Re: Design Exception #DE 17-04 – Design Exception – Mesa Estates Number of Lots  
Entering a Shared Drive

## DESIGN EXCEPTION #DE 17-04

RE: Number of Lots Entering a Shared Drive

Re: Mesa Estates  
REQUEST FOR TEDS EXCEPTION  
Driveway and Street Concessions

*Original layout*

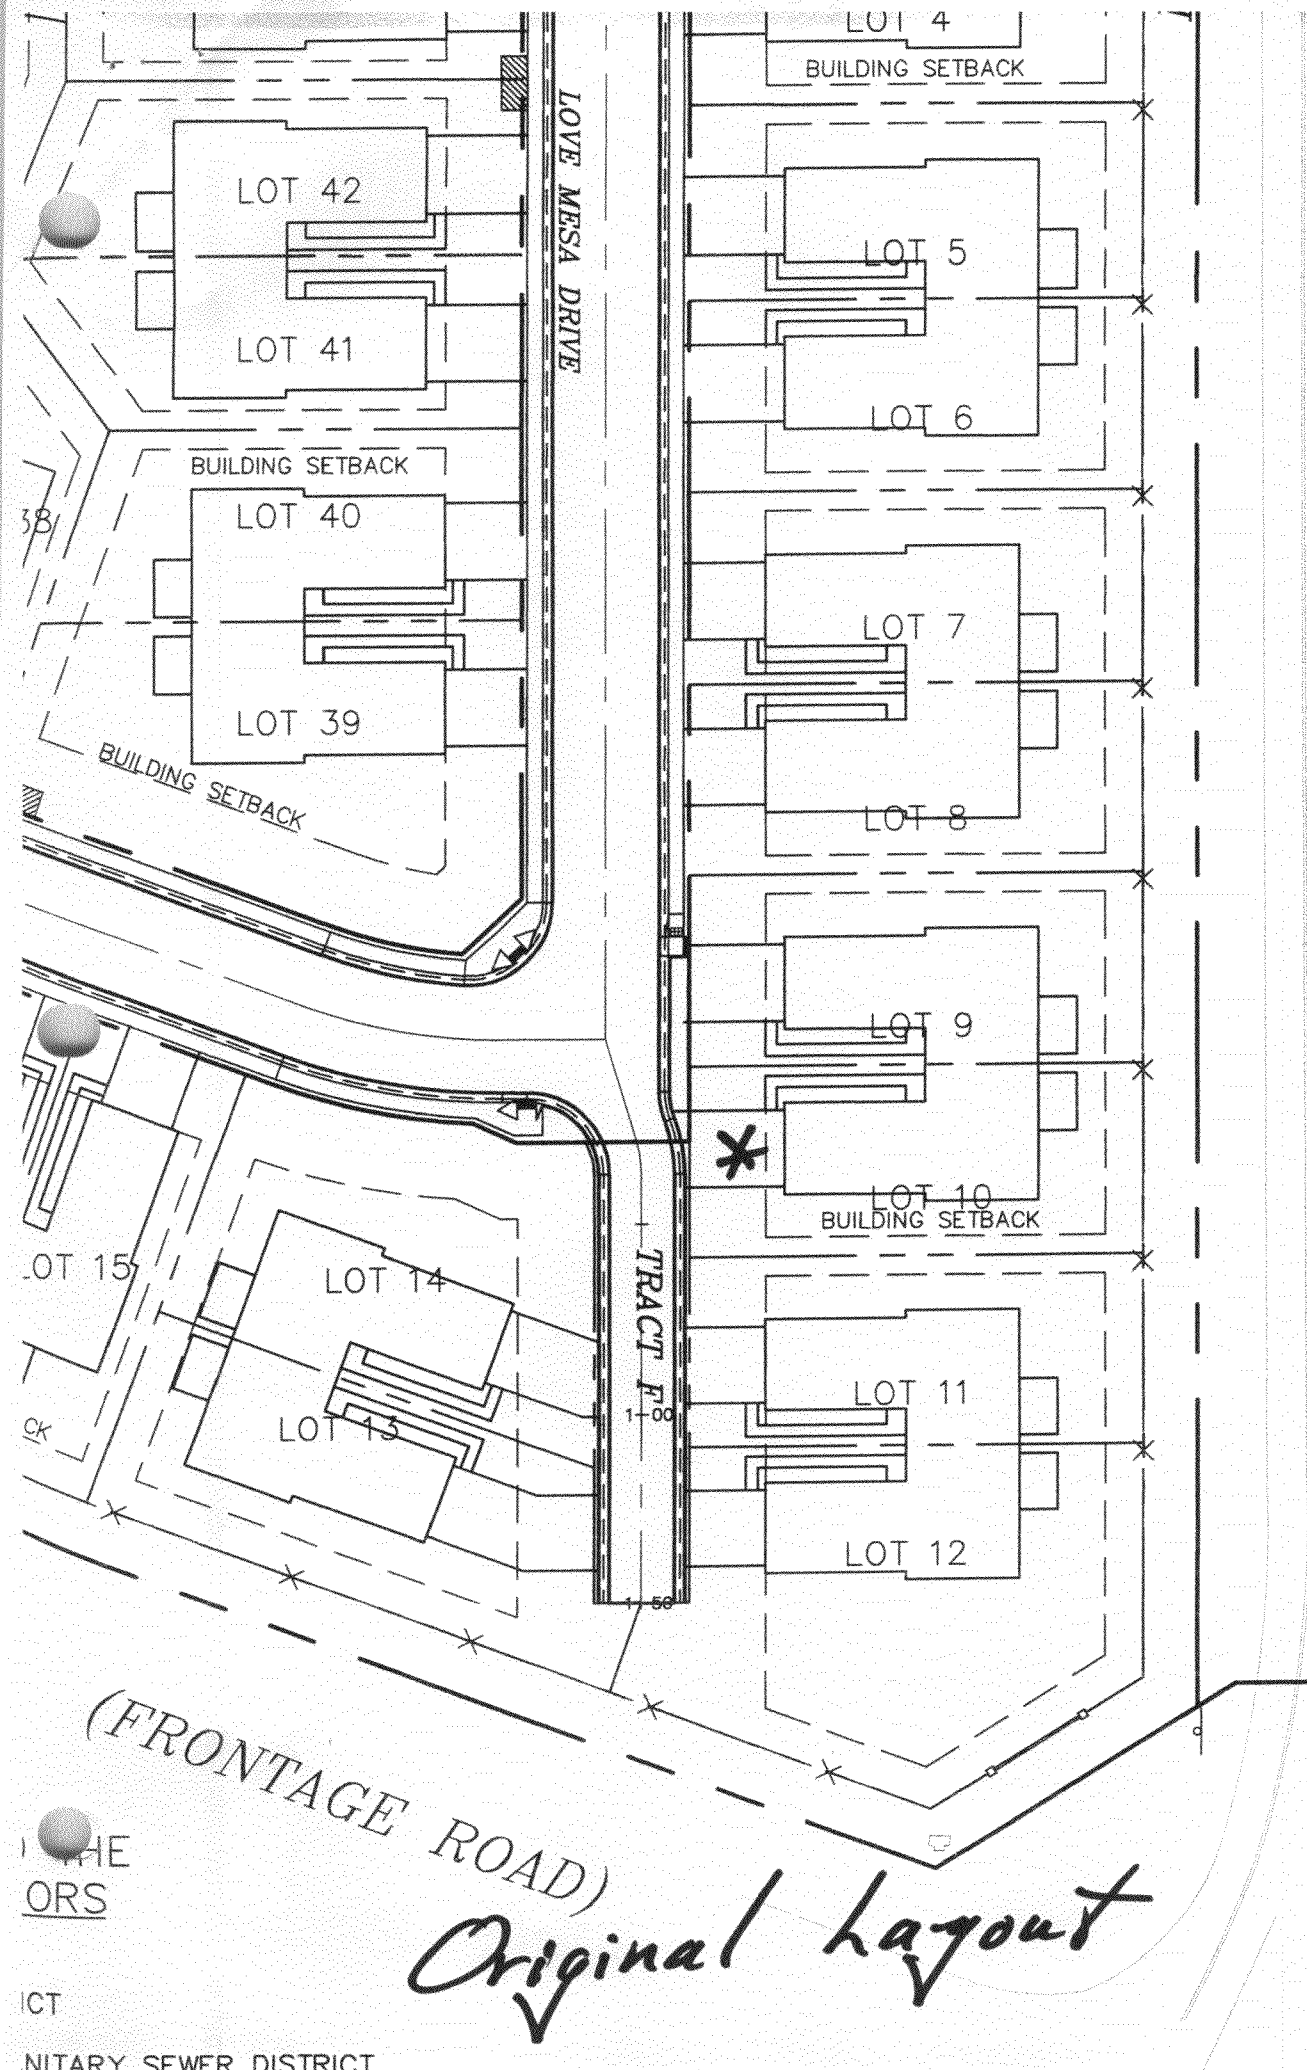
We are asking for an exception for the number of lots entering the private drive on Tract F.

We originally had a normal cul-de-sac where we now have a private Drive. No restrictions on driveways exist for standard street sections. The cul-de-sac was very short and required nearly twice the right-of-way and the bulb ran up to the south property line. We suggested a private drive to Eric Hahn and he agreed with us that it seemed the better solution. We did not take note of the fact that we had too many driveways entering the private drive.

We considered compressing the lots in Block 3 to pull lot 10 north to the standard street section, but this would have put the driveway immediately adjacent to the private drive at best.

*Proposed layout*

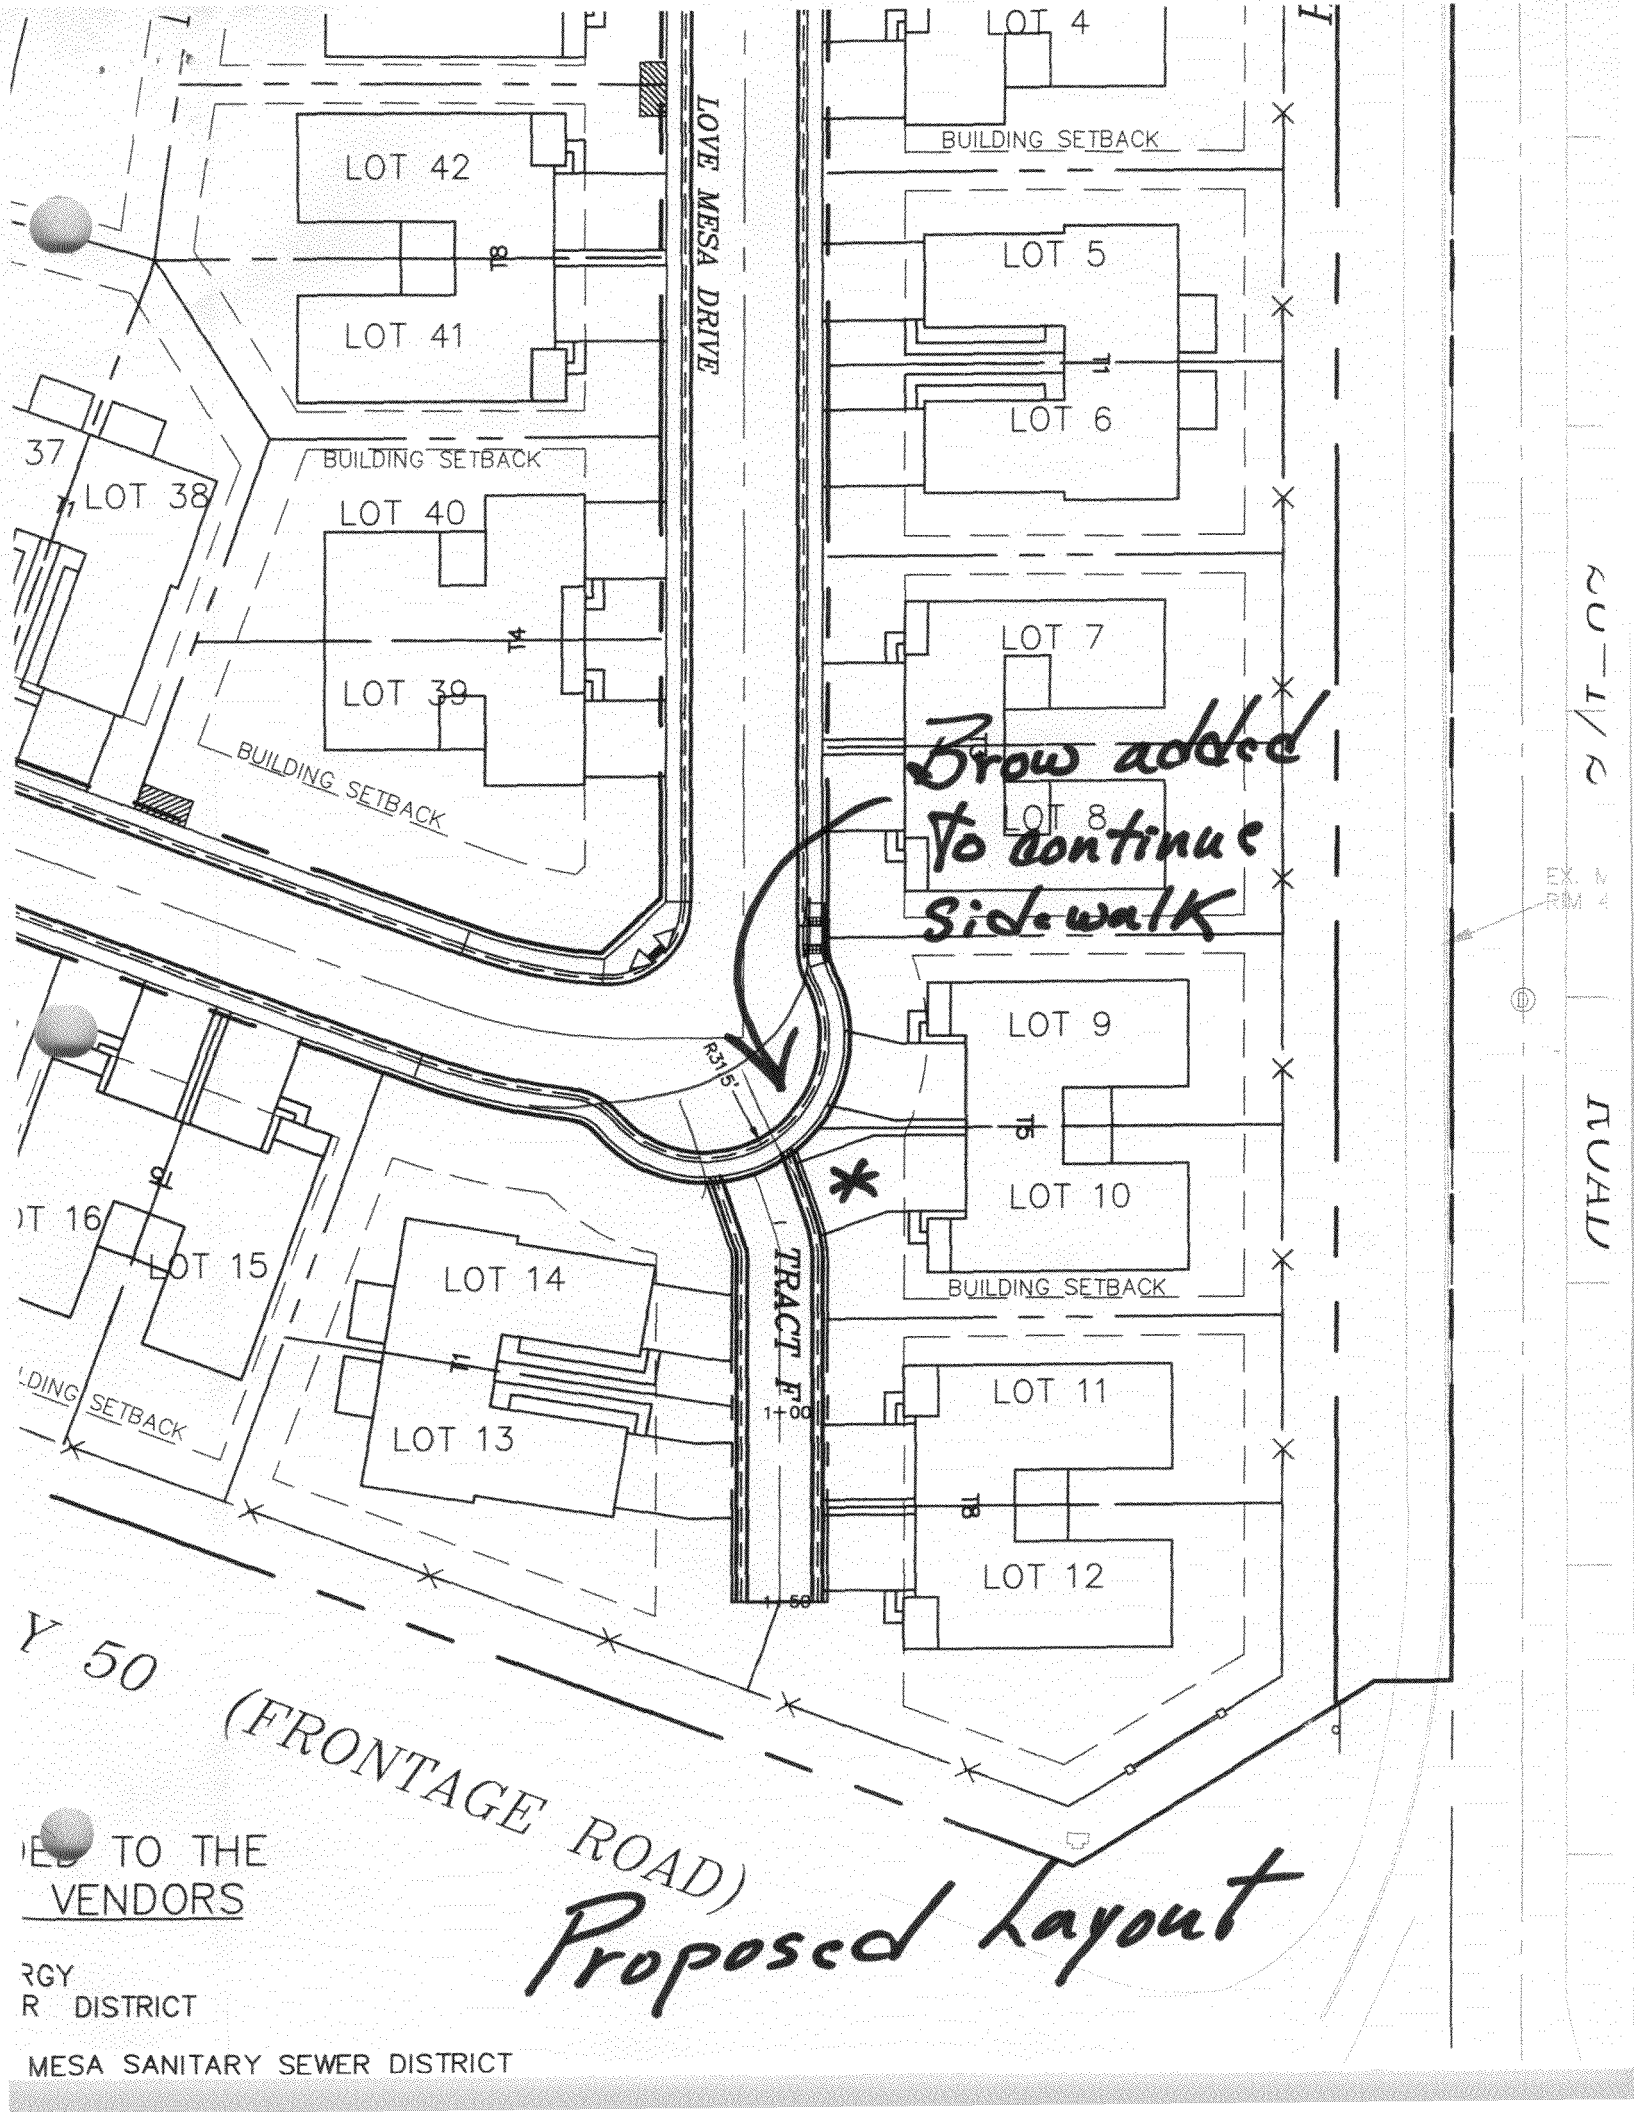
We feel that leaving the extra driveway entering on the private drive is a better solution than compressing the lots, making them less desirable and still only moving the driveway a short distance north to technically remove it from the private drive.

We feel that leaving the driveway where originally shown is less of an impact on the adjoining lots than the compression of all the adjoining lots would be just to get the space to move the driveway.

*Brow added  
to continue  
sidewalk*

Staff believes this Shared Driveway alignment is the best possible solution given the constrictions of the site and recommends approval of the Exception.
